HOWARD COUNTY HISTORIC PRESERVATION COMMISSION
ELlicott City Historic District ■ LAWYERS HILL HISTORIC DISTRICT
3430 Court House Drive ■ Ellicott City, Maryland 21043

March Minutes

Thursday, March 11, 2021; 7:00 p.m.

HPC-20-83 – 8049, 8055, 8059, 8061 (Tiber Park) and 8069 Main Street; Vicinity of Maryland Avenue and Main Street; Vicinity of 3711 Maryland Avenue along Patapsco River, Ellicott City – continued from December 3, 2020; January 14, 2021 and February 11, 2021

Figure 12 - Existing conditions and proposed culvert.

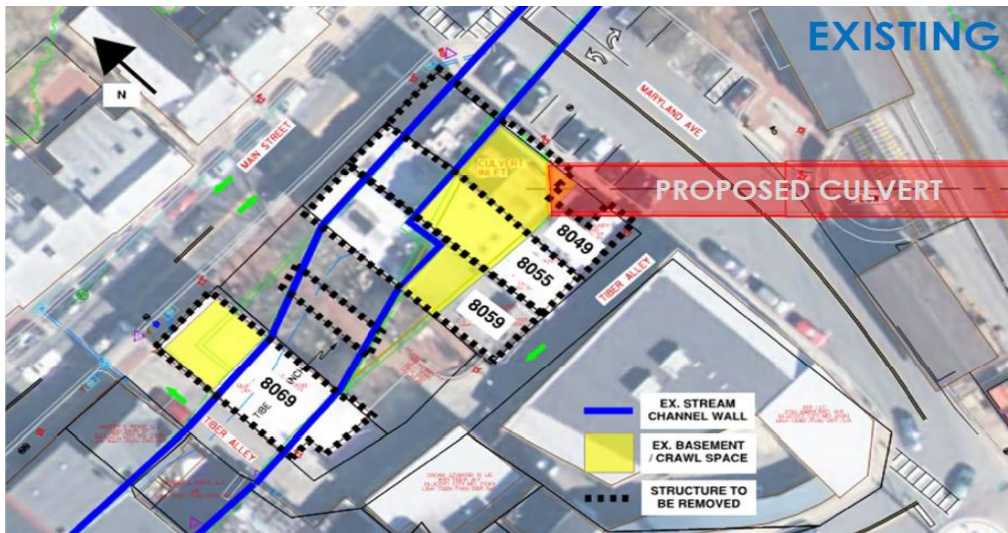
Slide 16 from Attachment A in the Applicant’s submission shows the existing stream channel with the location of the proposed culvert:

Figure 13 - Proposed terraced floodplain/culvert/expanded stream channel.

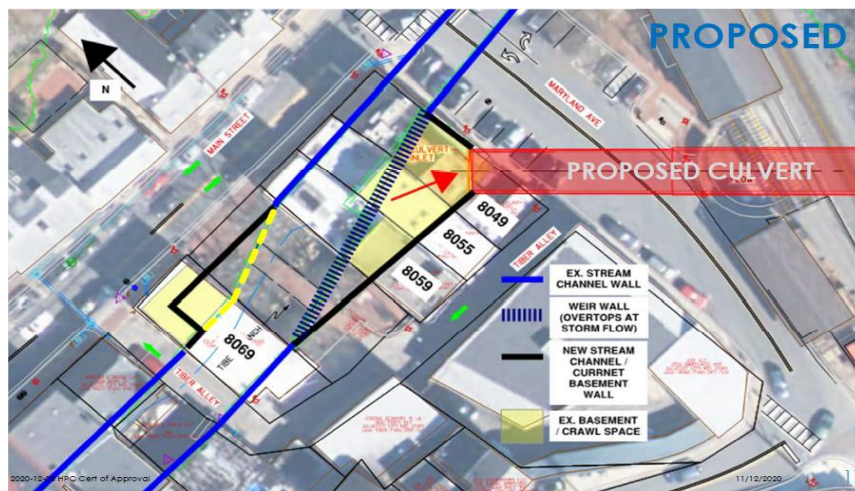
Slide 17 below from Attachment A in the Applicant’s submission shows the proposed stream channel with the proposed culvert and new terraced floodplain/new stream channel. The Applicant seeks approval for the construction of the expanded terraced floodplain/culvert/new stream channel as outlined in Items 6 and 7.

- **Condition 1** – Mr. Reich moved that approval was contingent on the County making a further submission on the final appearance of the channel walls, weir wall, river base and culvert headwall. Mr. Roth seconded. The motion was unanimously approved.
- **Condition 2** – Mr. Reich moved that condition of the approval that the Applicant provide architectural surface treatment of natural stone matching the existing stone walls as shown on slide 32 (Attachment A revised) showing the stone covering the face and top of the concrete walls. Mr. Roth seconded. The motion was unanimously approved.
- **Condition 3** – Mr. Reich moved to make condition of the approval that the County provide ongoing development of drawings and 100% completion of the drawings, so the Commission had opportunity to review them. Ms. Tennor seconded. The motion was unanimously approved.

- 1) Use a 4 to 6-inch stone veneer on the walls, with a stone veneer cap. No concrete should be visible.
- 2) Regarding the streetscape items, the Commission is looking for creative, permanent looking solution. They do not want to see hundreds of linear feet of black metal fencing, but rather something that will integrate better, such as bollards or stone piers.
- 3) Utilize brick sidewalks as per the Guidelines, instead of temporary measures. If the Applicant proposes to use something other than brick as the guidelines recommend, justify why the flood risk has not been mitigated yet.

Motion: Mr. Reich moved to approve the County's application for the Maryland Avenue bypass culvert project as amended and per the conditions spelled out. Mr. Roth seconded. The motion was unanimously approved.
